T10/07-312r1 SAS-2 Zoning route table entries for subtractive ports

To: T10 Technical Committee
From: Tim Symons, PMC-Sierra (Tim_Symons@pmc-sierra.com)
Date: 4 July 2007
Subject: 07-312r1 SAS-2 Zoning route table entries for subtractive ports

Figure 56 — Zoning expander route table

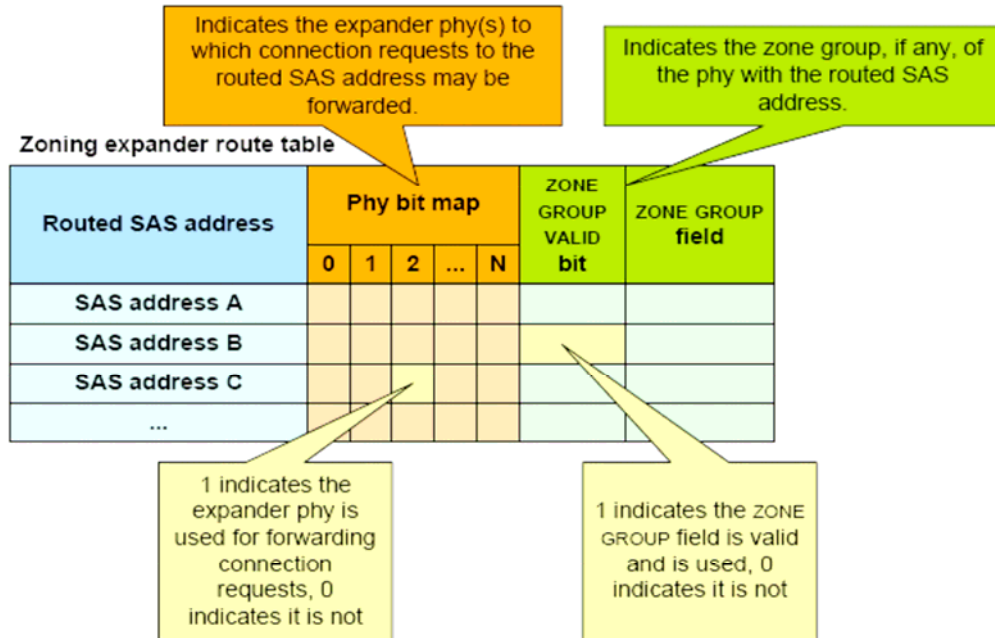
This is a proposal to include zone route table entries for devices attached to the subtractive port of expander and zoning expander devices.

A zoning expander route table is an expander-based expander route table (see 4.6.7.3) that is able to hold the zone group of ~~each~~ routed SAS addresses.

- 1) shall include discovered SAS addresses for all phys with the ROUTING ATTRIBUTE field set to 2h (i.e., table).
- 2) should include discovered SAS addresses for all phys with the ROUTING ATTRIBUTE field set to 1h (i.e., subtractive).

If the number of routed SAS addresses exceeds the value indicated in the MAXIMUM NUMBER OF ROUTED SAS ADDRESSES field then the zone route table should include SAS addresses for phys with the ROUTING ATTRIBUTE field set to 1h (i.e., subtractive) until the total number of routed SAS addresses in the zone route table is equal to the value indicated in the MAXIMUM NUMBER OF ROUTED SAS ADDRESSES field. The order for determining which routed SAS address for phys with the ROUTING ATTRIBUTE field set to 1h (i.e., subtractive) is vendor unique.
